EIC DIRC Laser Interlock PCB Revision

Marc McMullen
2023-09

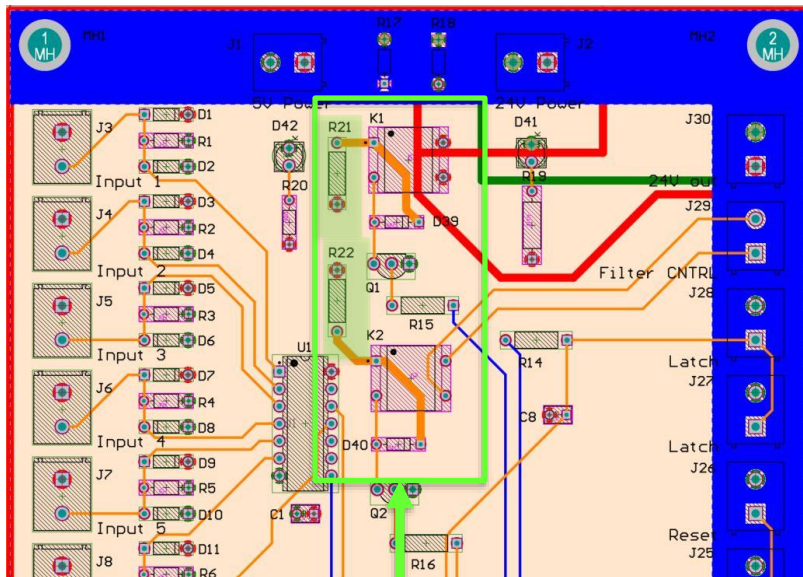
This month an engineering change order (ECO) was ordered for the EIC DIRC Laser Interlock board. An issue was found during the testing of the prototype version (revision 0). The board was burning up the relays when power was applied to the circuit. The engineer troubleshooted the circuit and determined that the relay coils were drawing too much current and needed an additional relay in series with the coil power circuit for each of the two relays. After determining the value of the relay, a modification of the schematic was developed, by hand and I carefully studied the changes to determine the correct change for the Altium schematic circuit. After making the change, I reviewed the schematic with the engineer to ensure the correction was as intended.

Notes
⊕ 8/1/2023 - on K1 and K2, a 330Ω resistor is needed between the 5V power and pin 1 on K1 + K2

330 Ω resistors R21 and R22 were added for Rev 1
